Hardwick Development Review Board
Conditional Use and Flood Hazard Review
Center for an Agricultural Economy
48 Granite Street, Hardwick
Application #2016-038
September 7, 2016

To consider a Conditional Use and Flood Hazard Review request by The Center for an Agricultural Economy (CAE) to create a parking area, install a water line, and replace/construct an accessory structure at an existing Outdoor Recreation site in the Village Neighborhood zoning district at 48 Granite Street, Hardwick.

Subject: Flood Hazard Review—Zoning Application No. 2016-038
 Replacement garden shed, waterline extension, parking area
 Atkins Field on Granite Street

Exhibit # 1

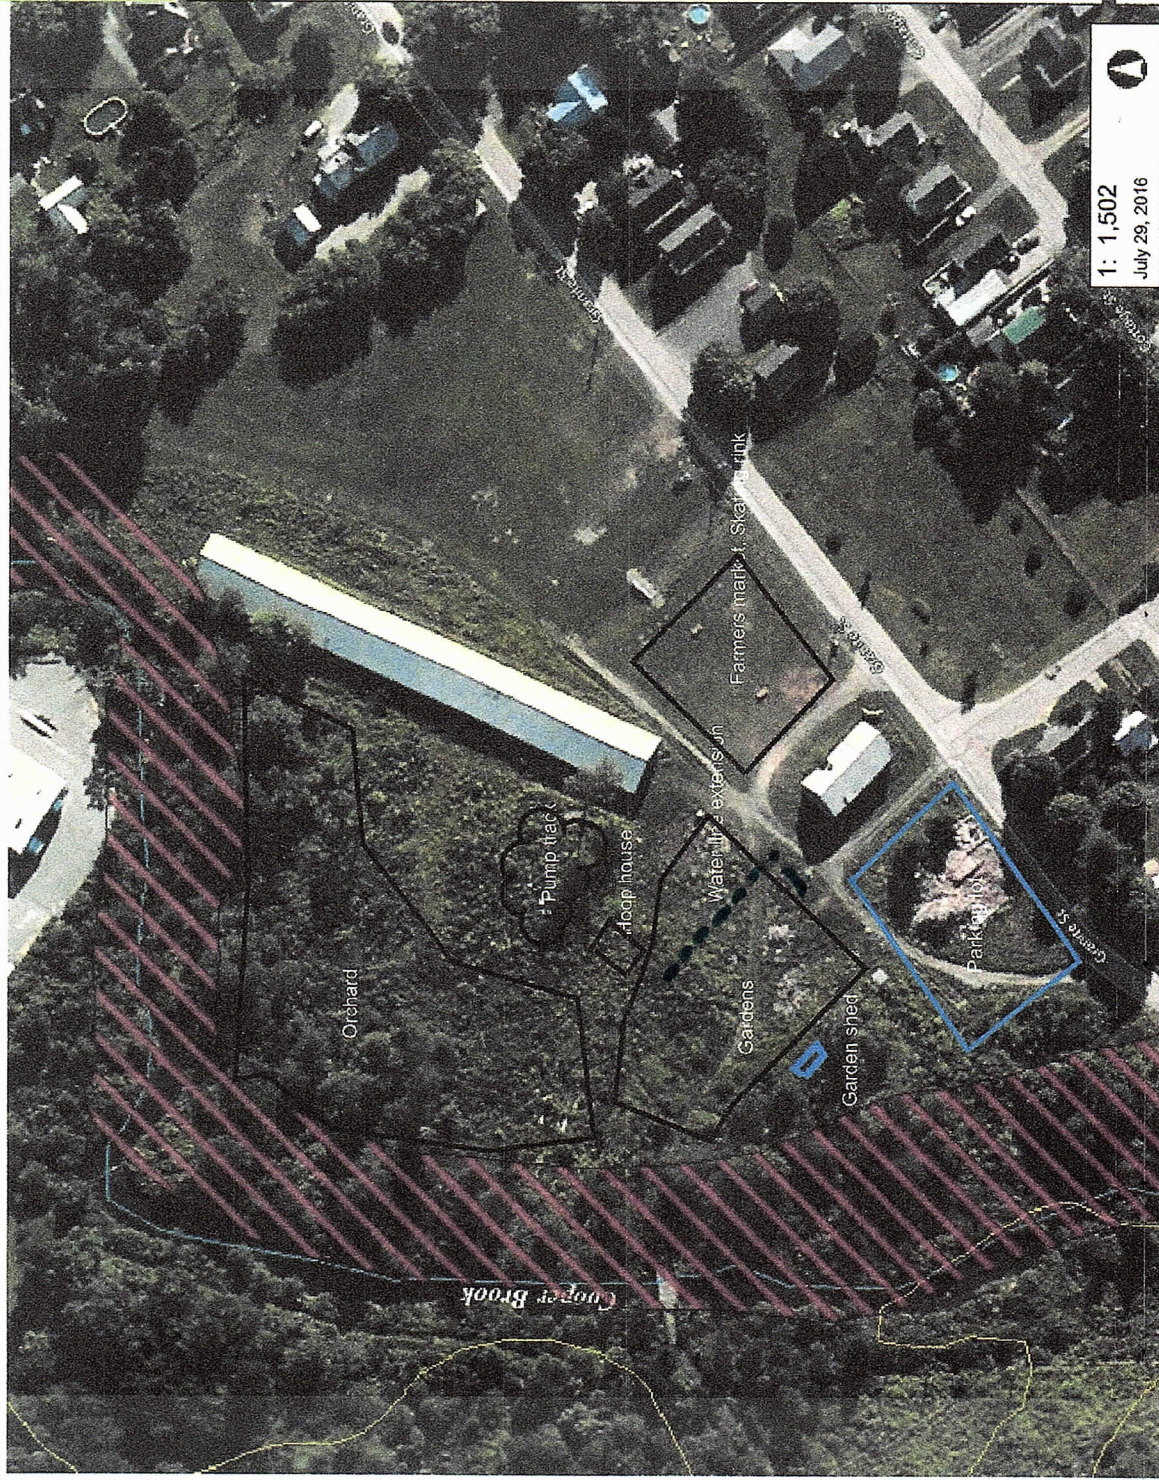
Section 5.3 C.4 requires that water supply systems “shall be designed to minimize or eliminate the infiltration of floodwaters into the systems and discharges from the systems into flood waters.” I recommend the town require a little more detail on how this standard will be met. For this project, the primary concern would be ensuring the water line and faucet are protected to prevent contamination of the system from floodwater. For example, NFIP guidance (see attached) calls for elevating outdoor faucets above Base Flood Elevation (BFE) or equipping the line with a backflow prevention device in the connection to the public water supply (which may already be present, I don't know). Also, the line should be adequately buried to protect it from breaking if flooding erodes away the surface soil.

- 1) The use be restricted to storage only;
- 2) The shed be located outside of the floodway as shown on the site plan;

I wasn't sure from the application if the finished parking lot level would match the surrounding ground level. I recommend this be the case if any new materials such as gravel are brought on site. The idea of matching the surrounding ground level is to keep as much floodplain area available for water to spread out, slow down, and be less damaging overall.

1. Any and all necessary state and federal permits must be in place before development can commence.
2. The water line and faucet will be protected to prevent contamination of the system from floodwater by the installation of 2 frost-free hydrants equipped with back flow preventers.

3. The new water line shall be adequately buried to protect it from breaking if flooding erodes away the surface soil.
4. The accessory structure shall be restricted to non-hazardous storage use only.

5. The accessory structure shall be located outside the floodway.
6. The flood openings on the accessory structure shall be kept free of obstruction and the bottom of all openings shall be located no more than 1 foot above the ground level;

7. All building materials in the accessory structure below BFE shall be flood damage resistant.
8. The finished parking lot level shall match the surrounding ground level.

CAE- Atkins shed - (garden shed)
bolt attachment
to granite

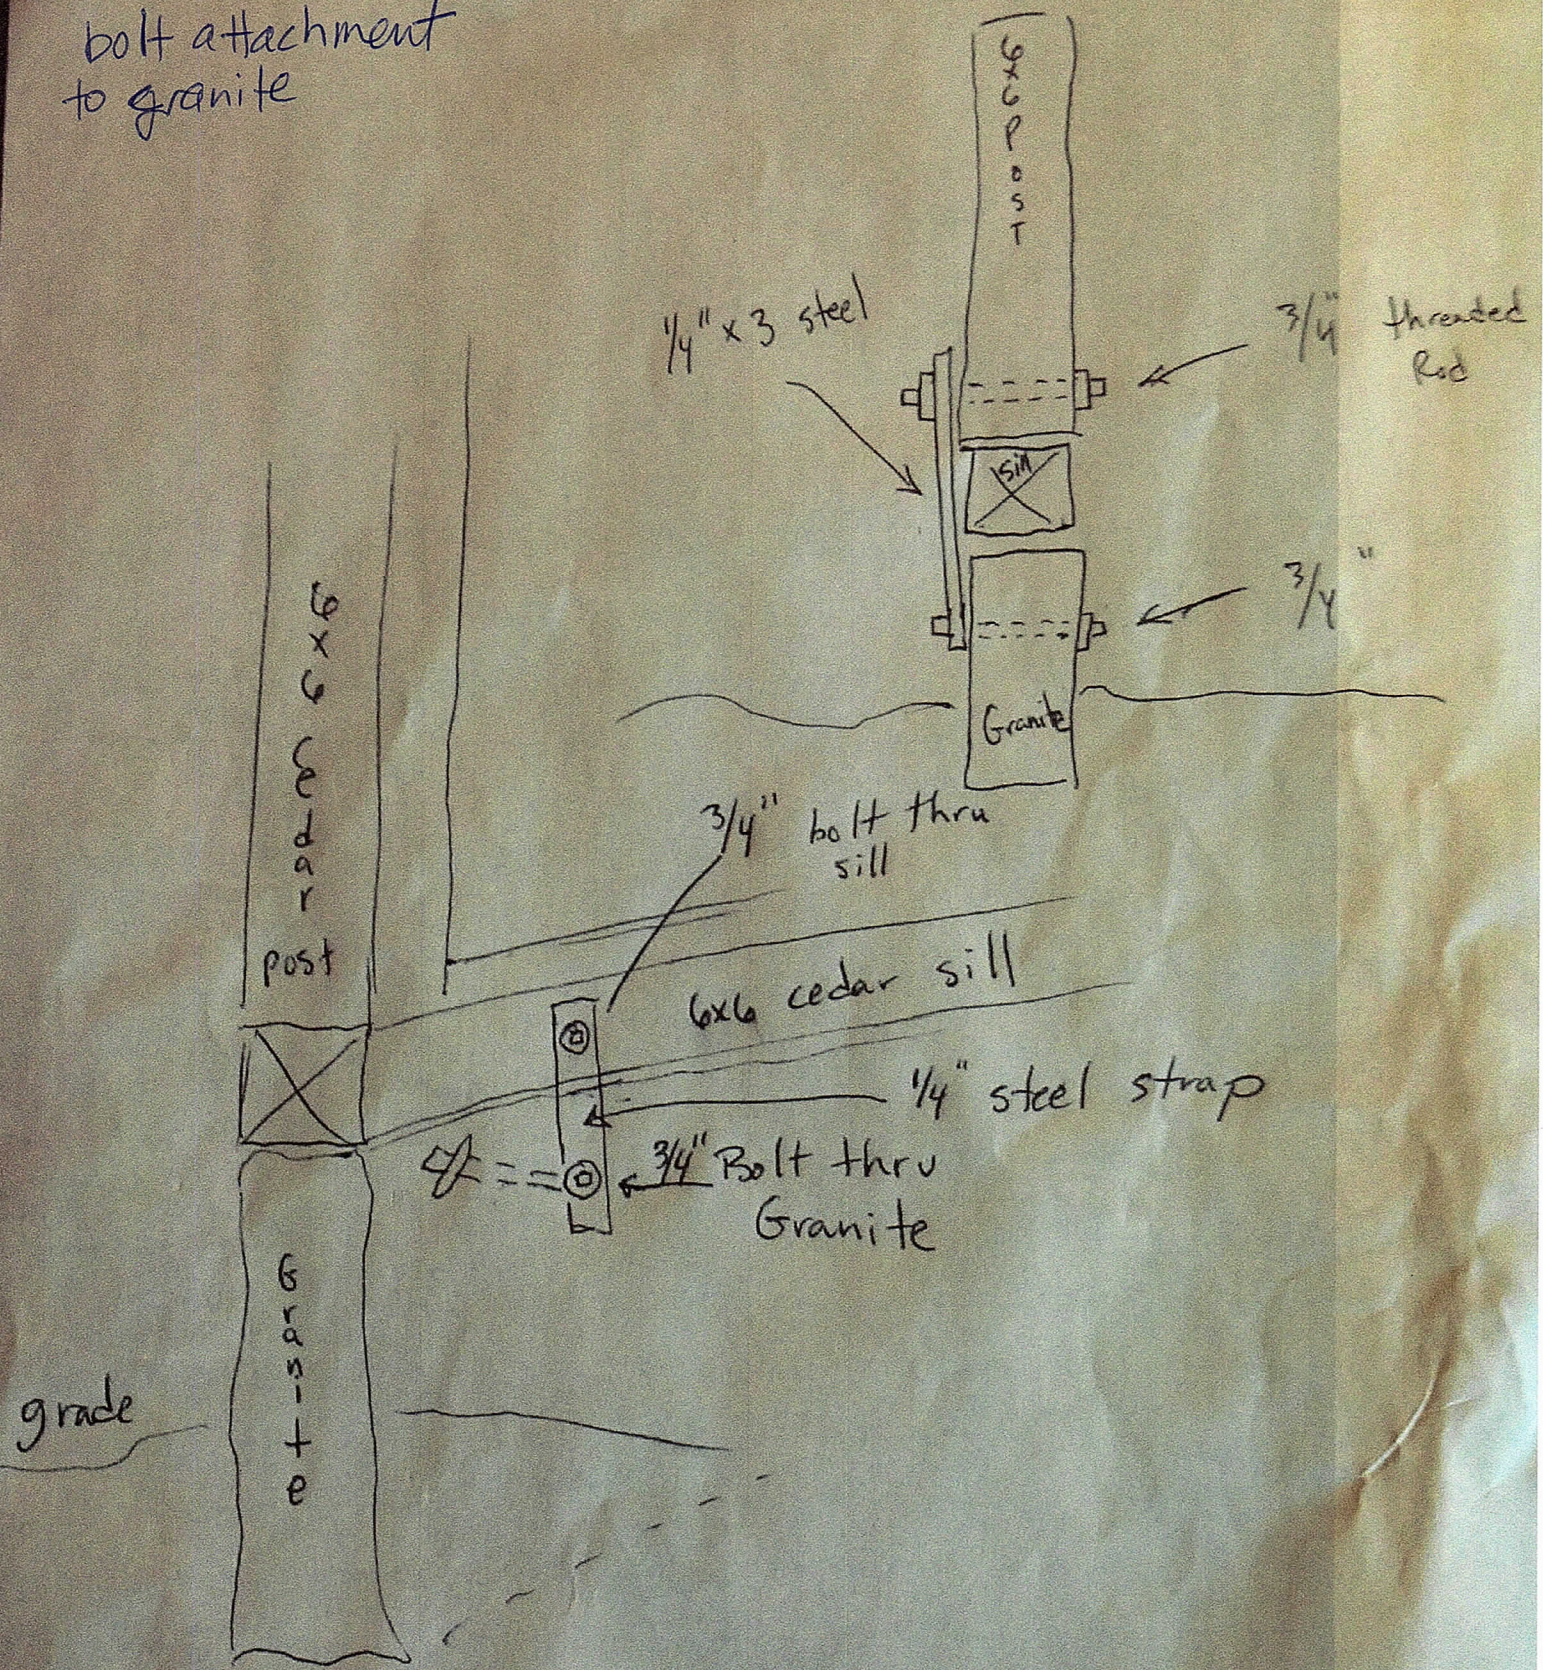
Sacha also stated that the shed must be anchored. The initial proposal suggested chaining the shed to large granite blocks. The builder suggested that attaching the building to the blocks and essentially creating a foundation with the blocks would be beneficial to the overall durability of the structure. (See Exhibit #2). The shed will be used for tools, compost and will not be used for any hazardous materials. No human habitation will be allowed in the structure and no electrical or heating facilities will be within the structure.

Atkins Field garden shed - ~~the~~ cedar

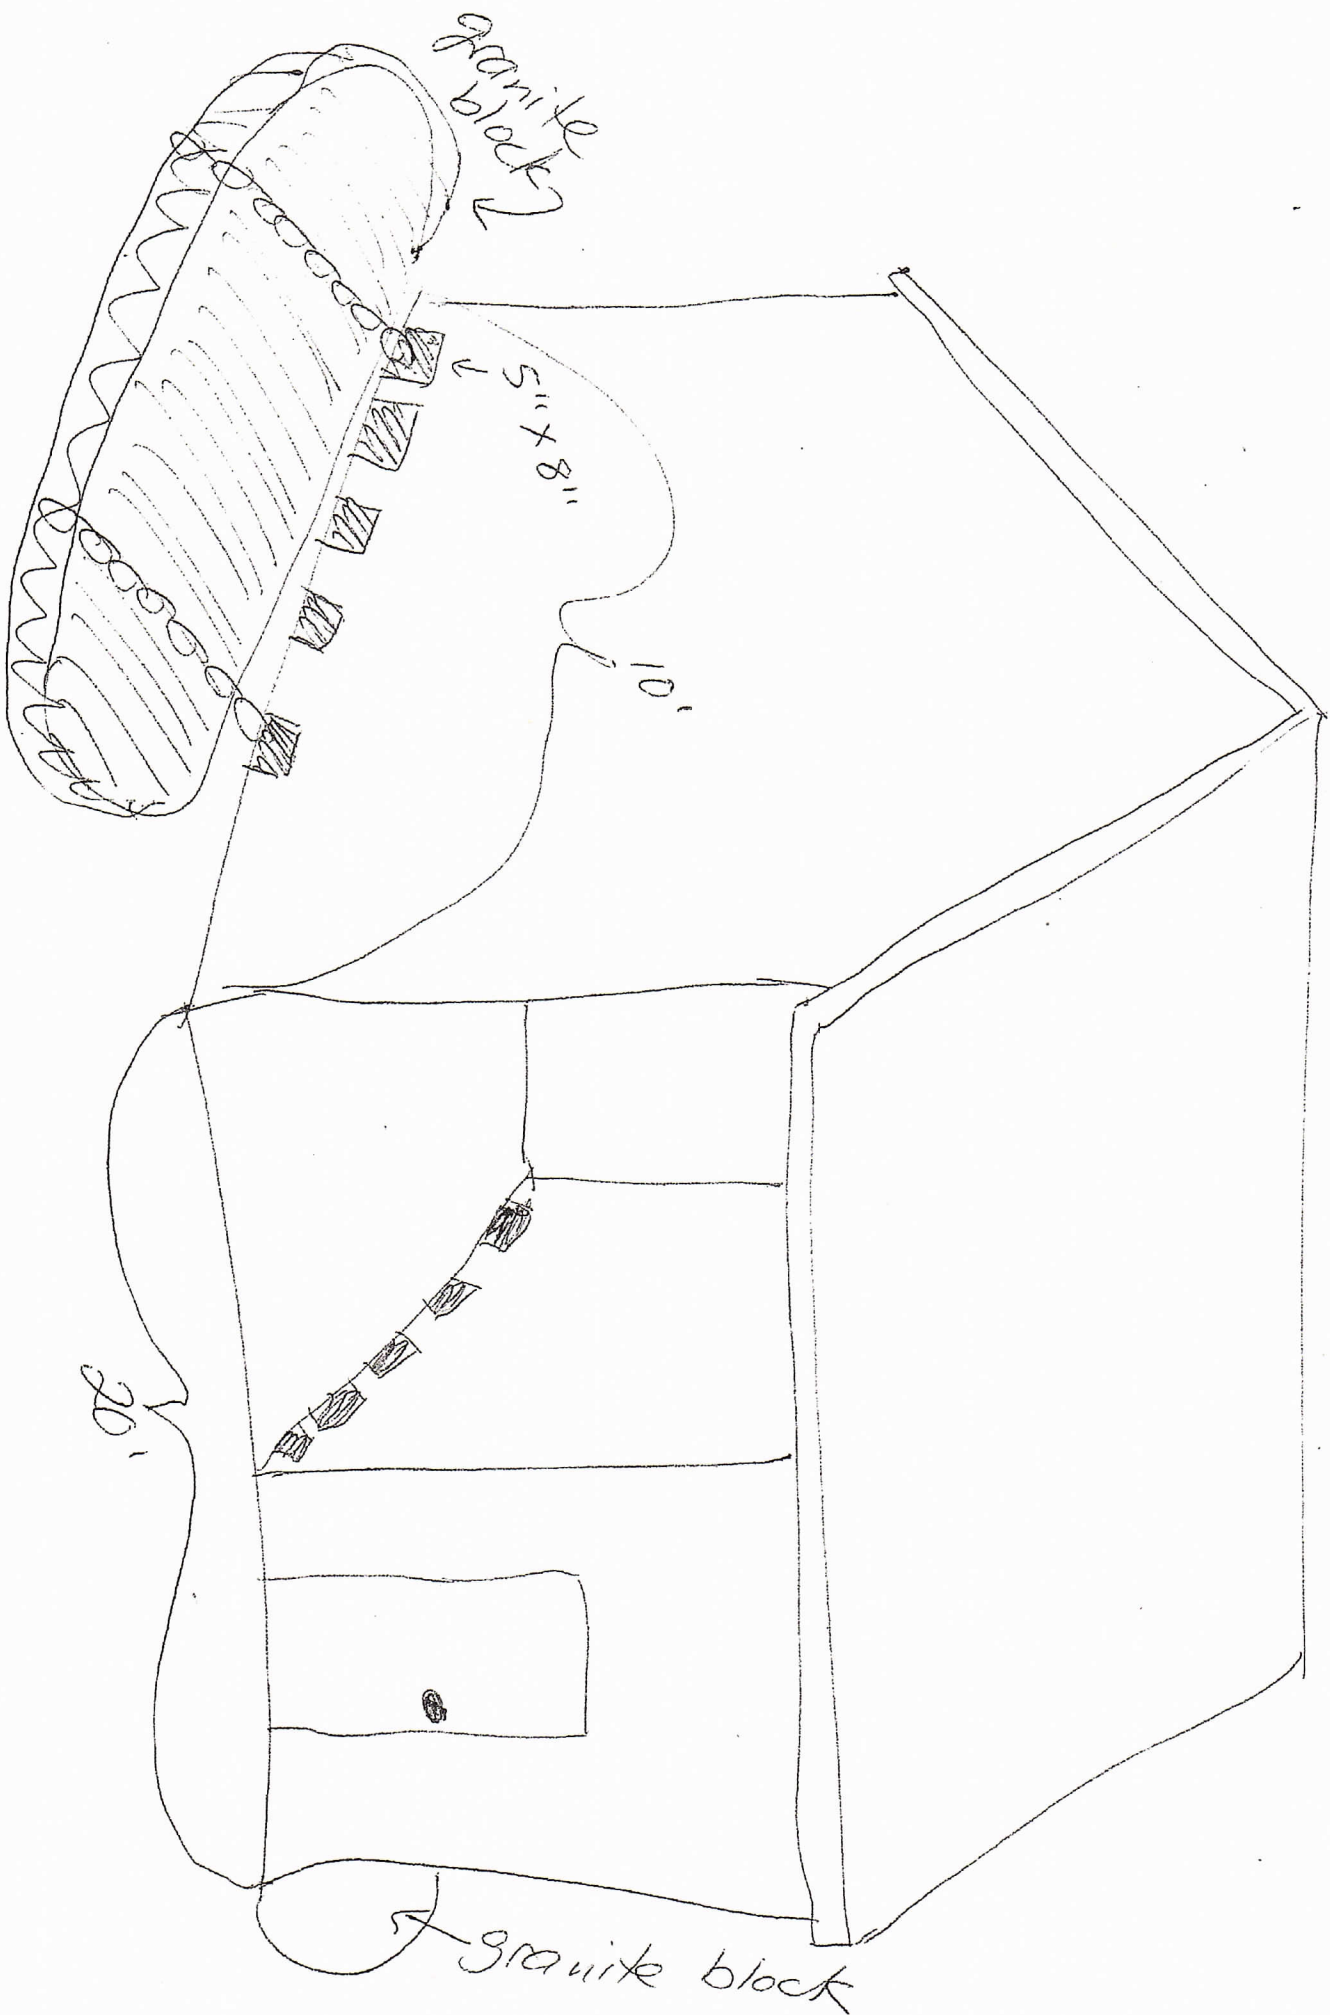
- 3) The flood openings be kept free of obstruction and the bottom of all openings be located no more than 1 foot above the ground level;
- 4) All building materials below BFE be flood damage resistant as described in [NFIP Technical Bulletin 2](#). My understanding is hemlock is not generally as decay resistant as other woods (e.g. cedar), unless it has been treated. I recommend the town request confirmation the building materials will be decay resistant or otherwise acceptable by FEMA guidance.

Chair Michaels read the Flood Hazard suggestions rendered by Sacha. It was noted that the shed is now proposed to be cedar (instead of hemlock – see Exhibit #4). It was also noted that the water line extension will have a 1” plastic pipe to 2 frost-free hydrants which will have back flow preventers (See Exhibit #3) on them to address Sacha’s concerns. The line will be at the same depth as the Town Water line. The parking area shall match the surrounding ground level as per Sacha’s suggestion.
